Decision on an application to change/cancel conditions of a resource consent under section 127 of the Resource Management Act 1991

Application numbers: SUB60035991-B, LUC60010513-C, DIS60048302-A

Applicant: AV Jennings Hobsonville Pty Limited

Site address: Hall Farm, State Highway 1, Upper Orewa

OREWA WEST SUBDIVISION DEVELOPMENT		
GRAND DRIVE, OREWA		
Road Access off Northern Motorway Interchange		
A3 Scale 1:500		
Traffic Solutions Ltd 82 Hindmarsh Drive, Tauranga 3110 Ph: (07) 376-5051		Drawn: JPC Date: 09/08/2016
Drawing No:		712/1

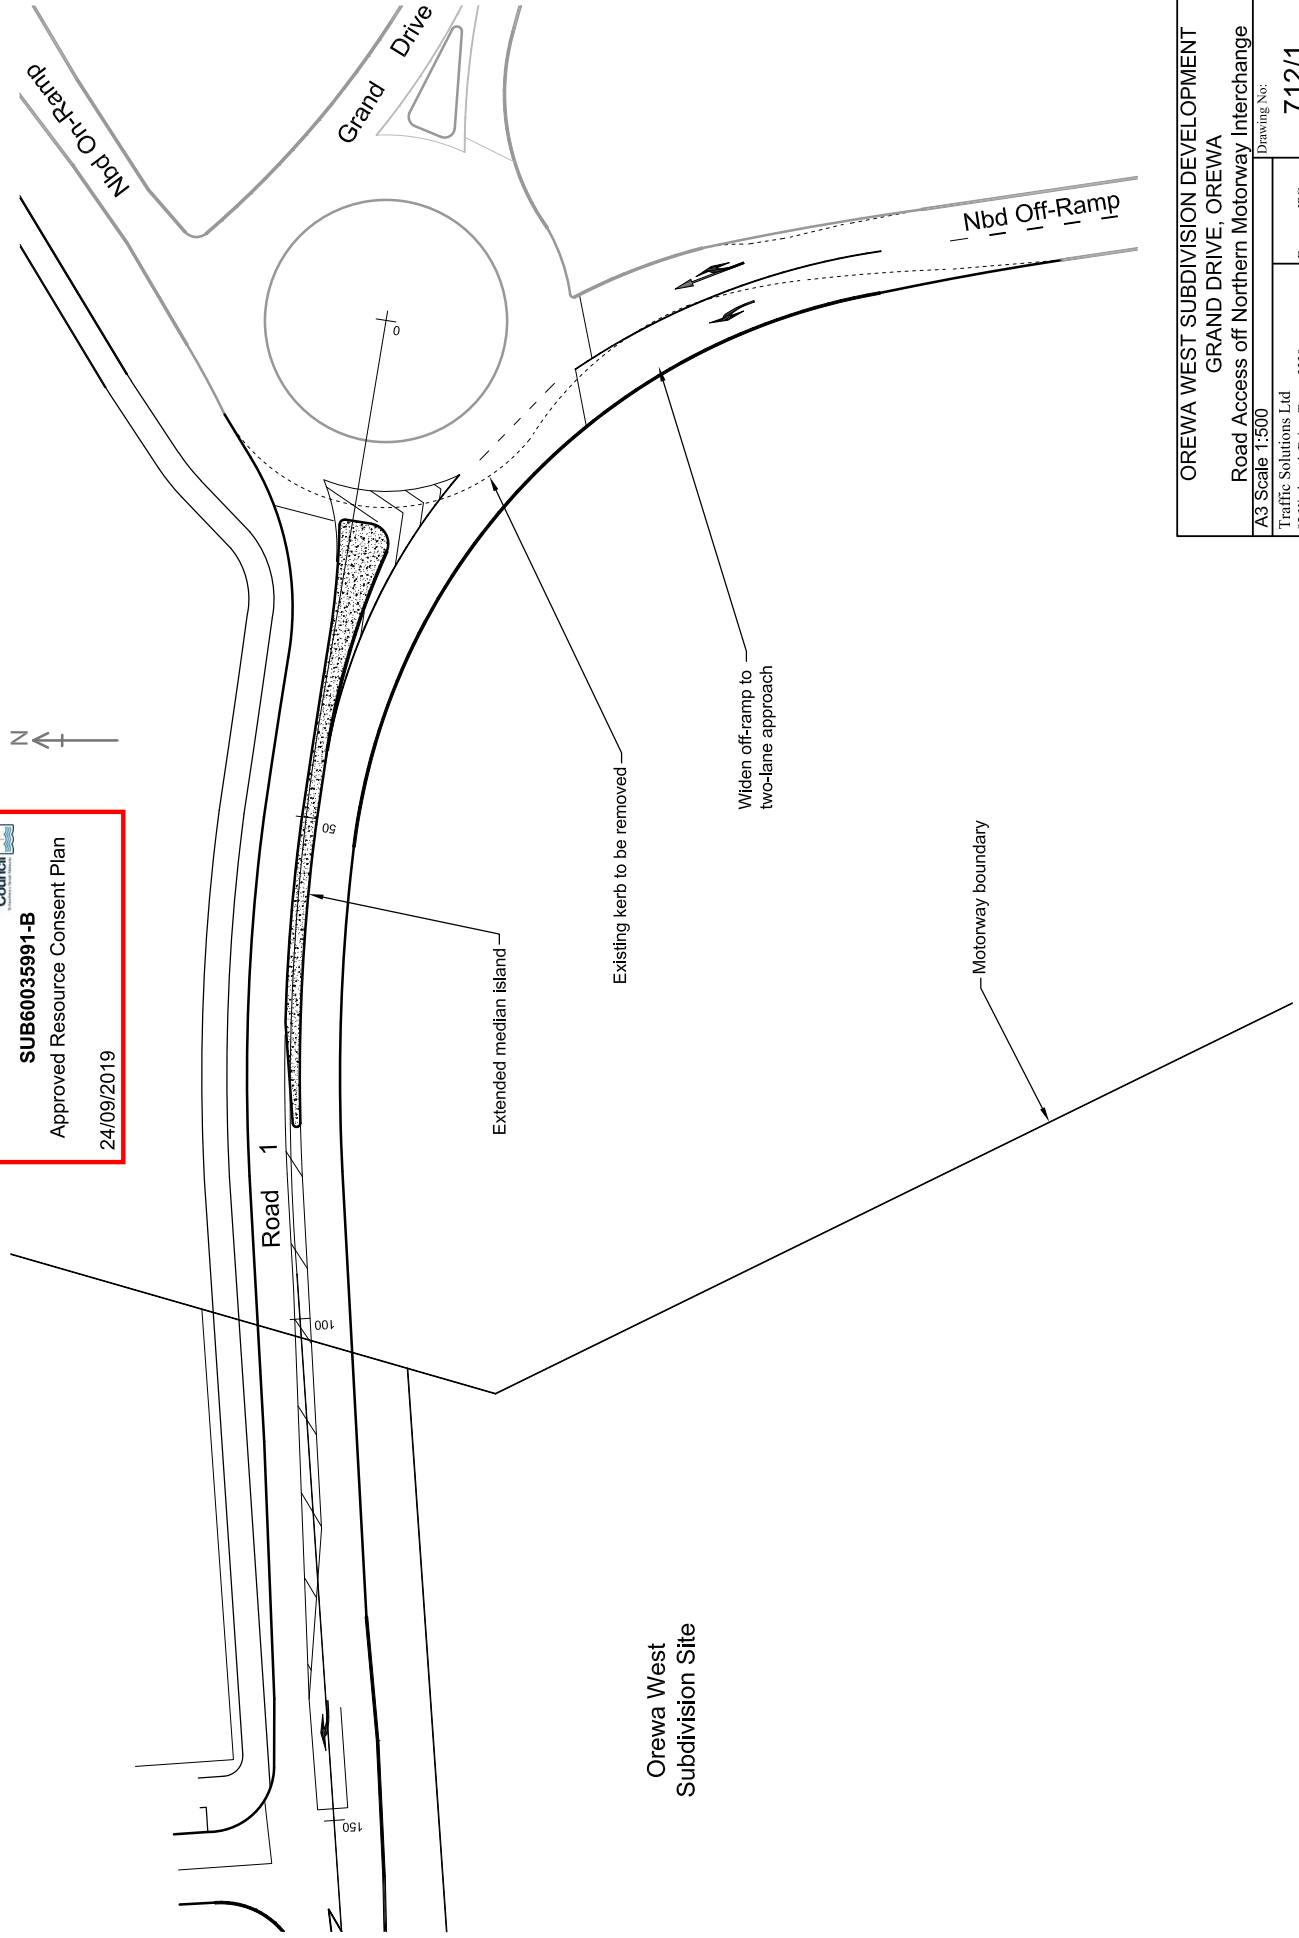
- (l) Detailed design of a new left turn lane to be constructed on the northbound offramp at the approach to the western interchange roundabout, generally as per Traffic Solutions Ltd Dwg.712/1. Detailed engineering design plans shall be submitted to NZTA prior to construction, and implemented in accordance with NZTA requirements. The slip lane shall be constructed and operational upon completion of Section 224(c) for Stage 1.

Drawing Title	File No	Rev	Draw No
PROPOSED ROAD LAYOUT PLAN	12516-01-S127	E	300

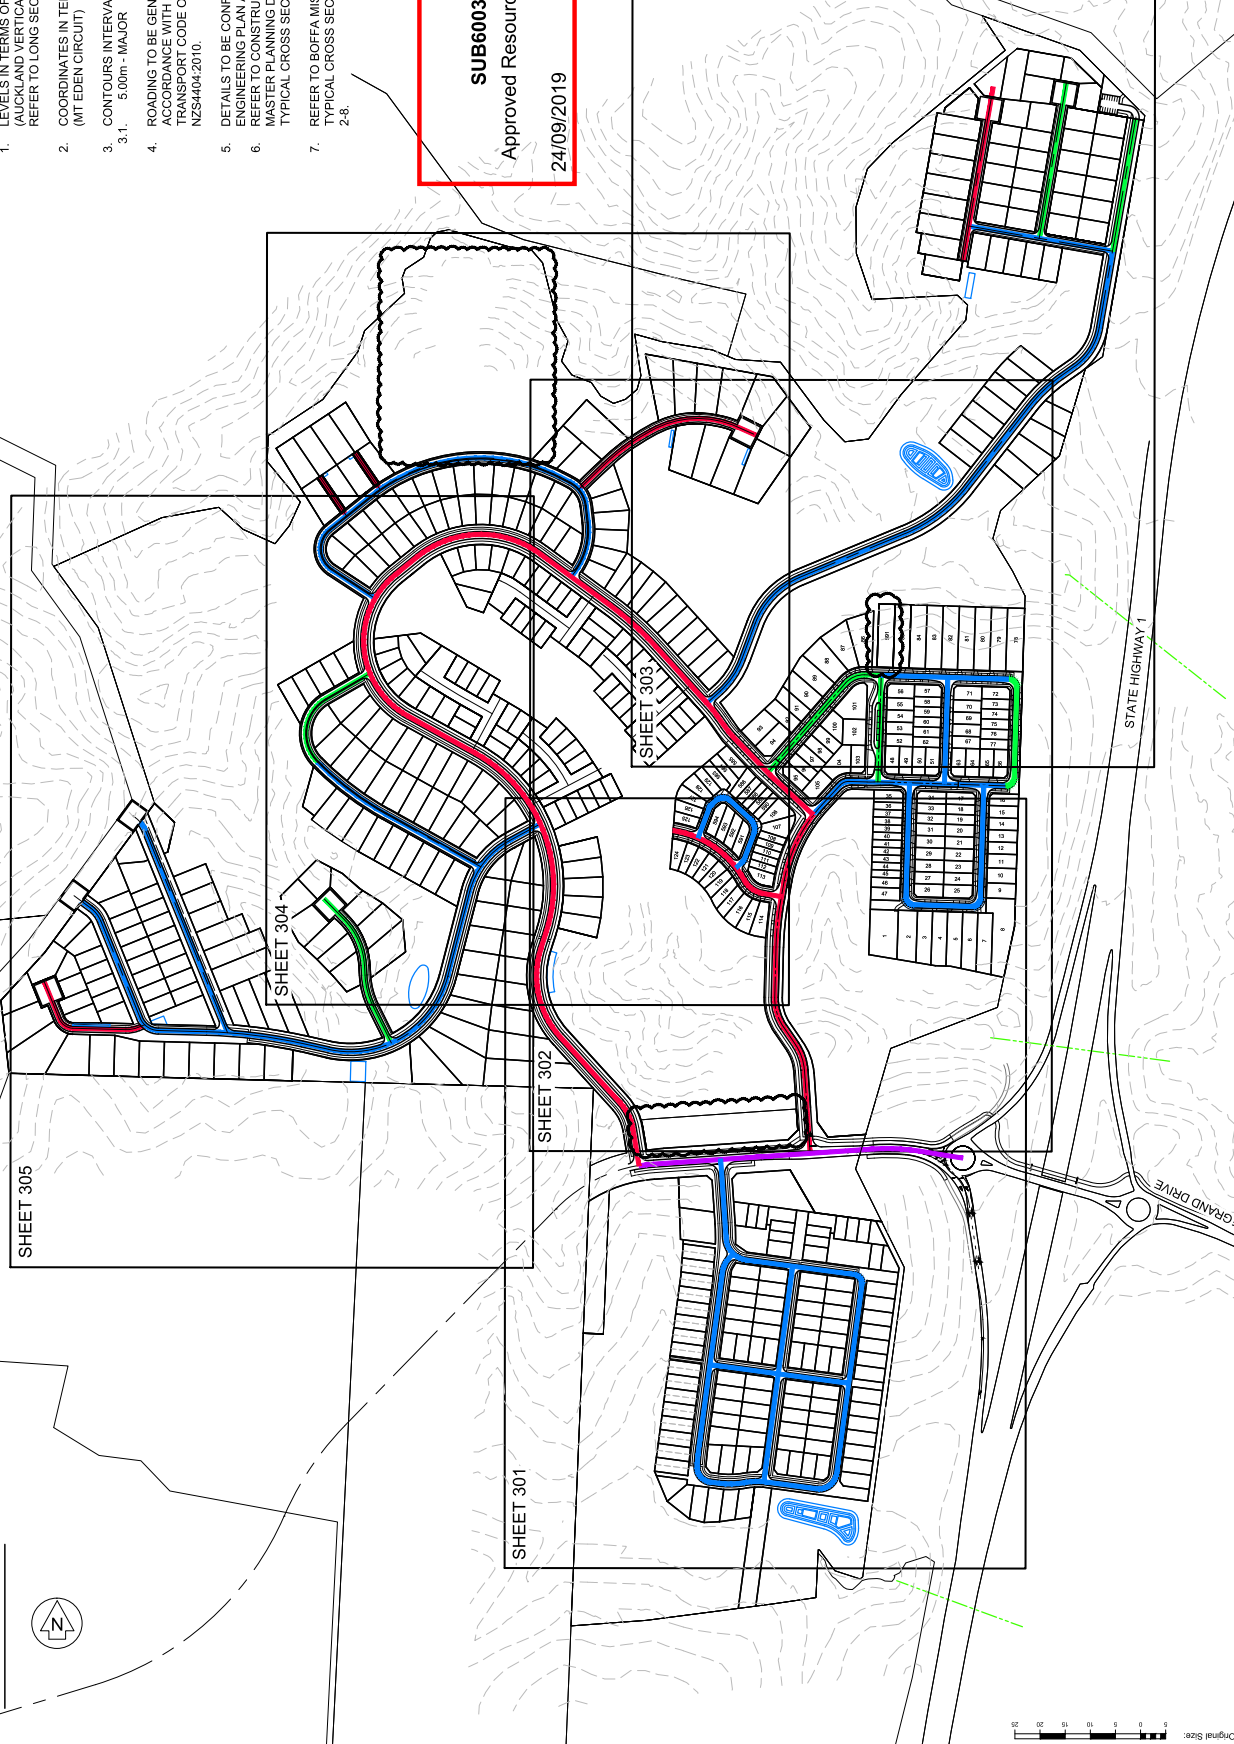
Design of a local road (Road 1) to be formed from the entry road across the site to the western boundary as generally outlined on the plan ~~12516-01S127 300 Rev B~~ 12516-01S127 300 (dated May 2019) and 302 (dated 05/08/19) Rev E prepared by Airey Consultants Limited. The design of Road 1 shall ensure a threshold treatment is provided at an appropriate distance from the motorway interchange to encourage drivers to lower vehicle speeds before entering the site. The gradient of Road 1 shall be designed and constructed in accordance with the Auckland

- (f) Design of a local road (Road 1) to be formed from the entry road across the site to the western boundary as generally outlined on the plan 12516-01S127 300 Rev E prepared by Airey Consultants Limited. The design of Road 1 shall ensure a threshold treatment is provided at an appropriate distance from the motorway interchange to encourage drivers to lower vehicle speeds before entering the site. The gradient of Road 1 shall be designed and constructed in accordance with the Auckland Transport Code of Practice and the Austroads Guide to Road Design. The design of the Road 1 shall be submitted with the engineering plans for Stage 1.

Drawing Title:
**PROPOSED ROAD LAYOUT PLAN -
SHEET 2 OF 5**

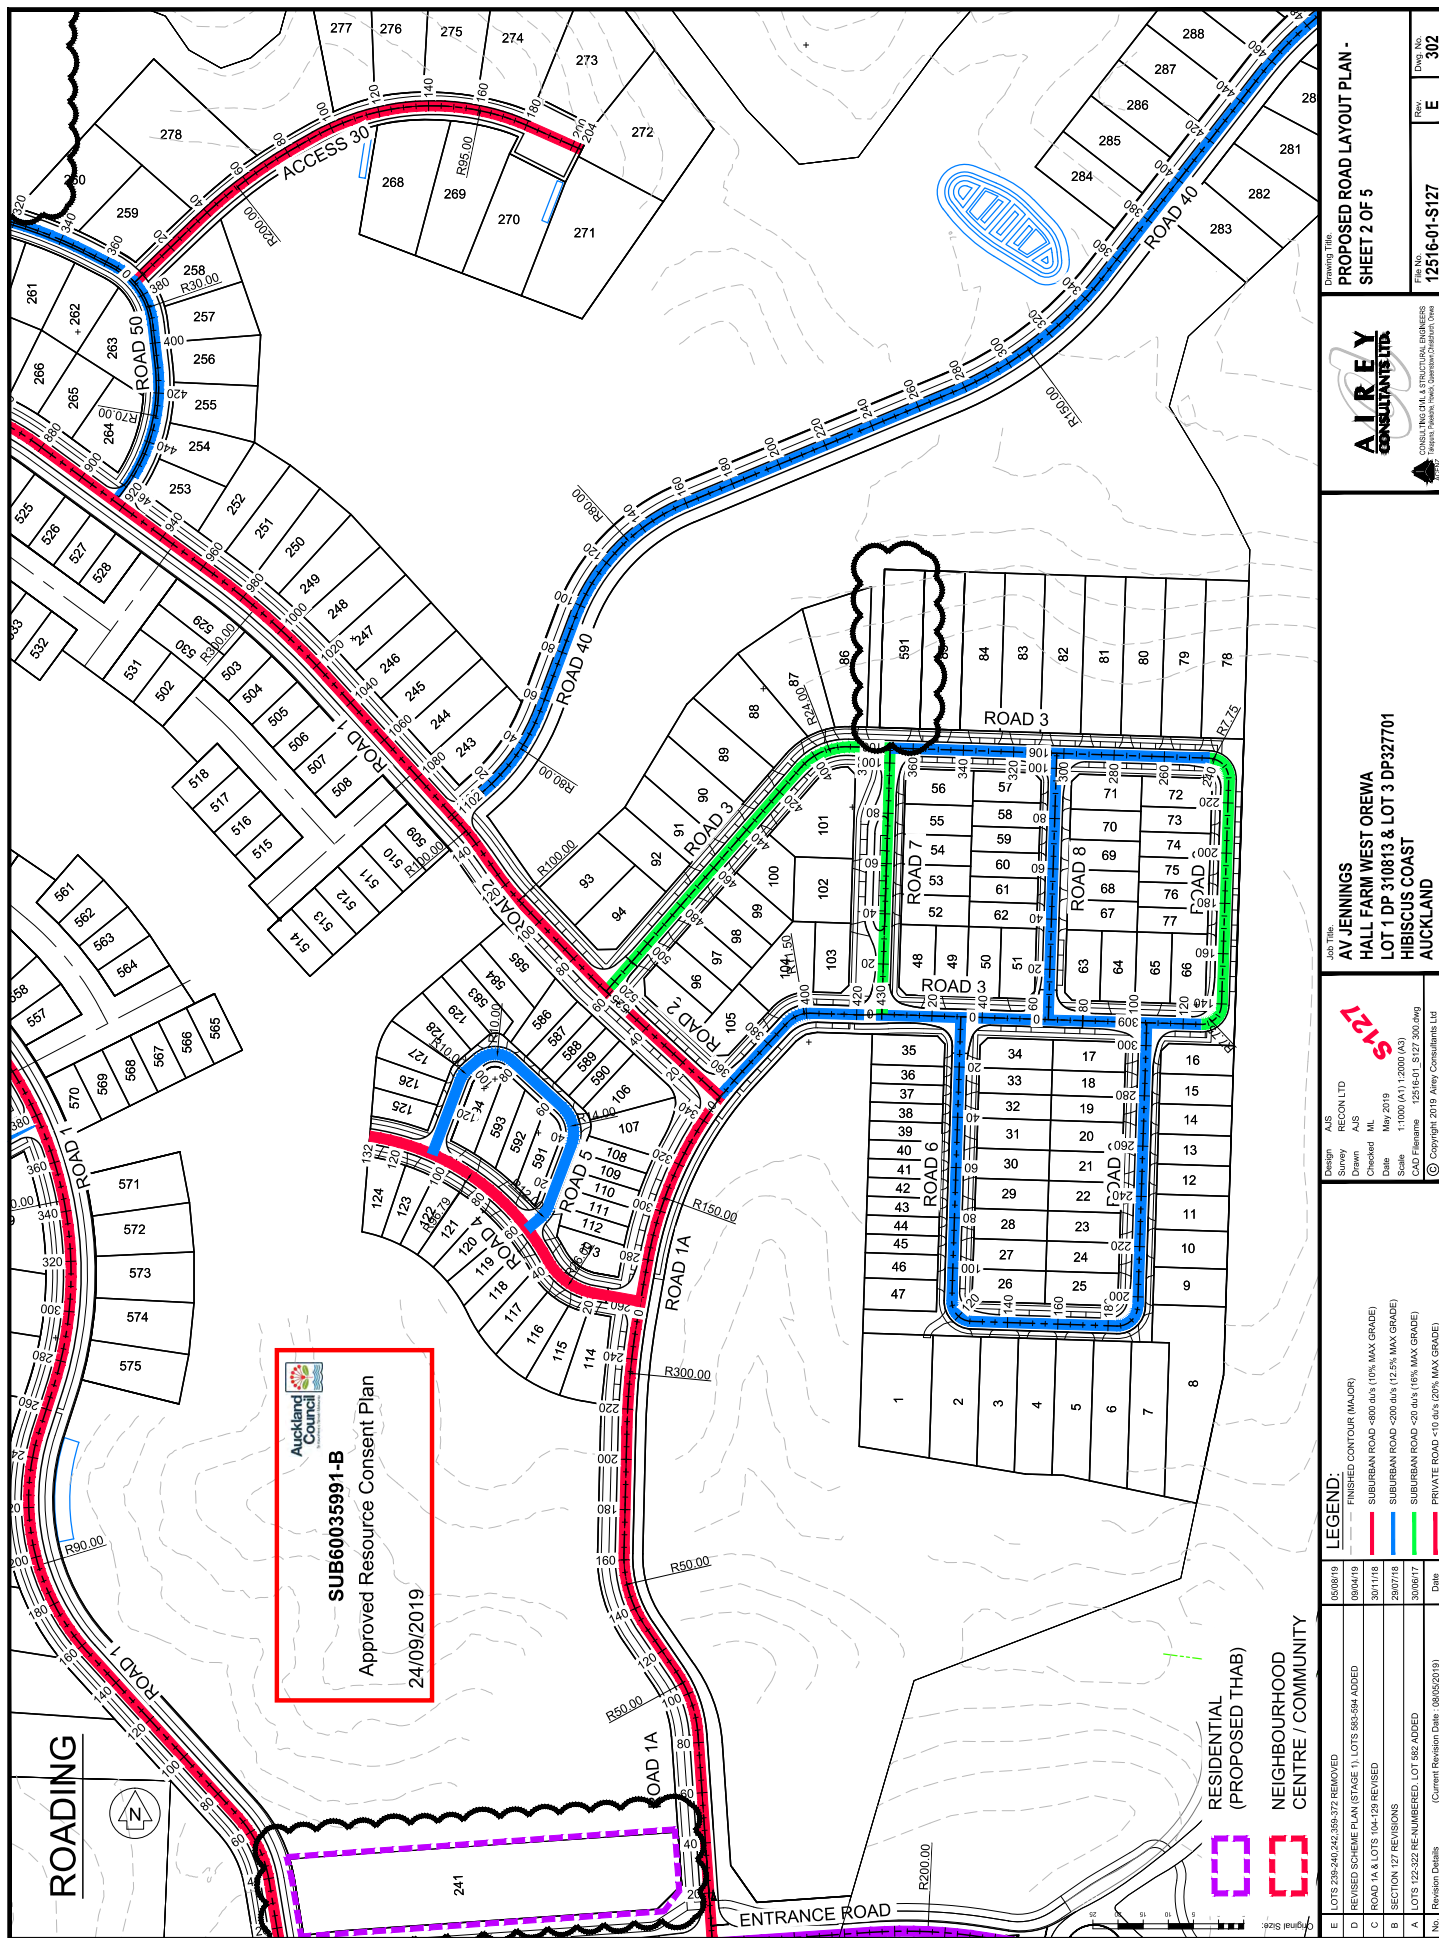
In the event of any inconsistency between the approved drawings and supplementary documentation, the approved drawings will prevail. In the event of any inconsistency between the approved drawings, plan ~~12516-01S127 300 Rev B~~ 12516-01S127 300 (dated May 2019) and 302 (dated 05/08/19) Rev E prepared by Airey Consultants Limited will prevail.

2. Unless any changes are required by the conditions below, the land use, discharge, stream works, subdivision and water take activities shall be carried out in general accordance with the plans and all information submitted with the application, detailed in Appendix 1, and all referenced by the Council as consent numbers LUC60010513 (landuse), SUB60035991 (subdivision), DIS60048302 (stormwater discharge), DIS60048335 (wastewater discharge), LUS60048380 (stream works) and WAT60051016 (water permit) and as varied by consent LUC60010513-A, and LUC60010513-B, LUC60010513-C, SUB60035991-B and DIS60048302-A
3. In the event of any inconsistency between the approved drawings and supplementary documentation, the approved drawings will prevail. In the event of any inconsistency between the approved drawings, plan 12516-01S127 300 Rev E prepared by Airey Consultants Limited will prevail.
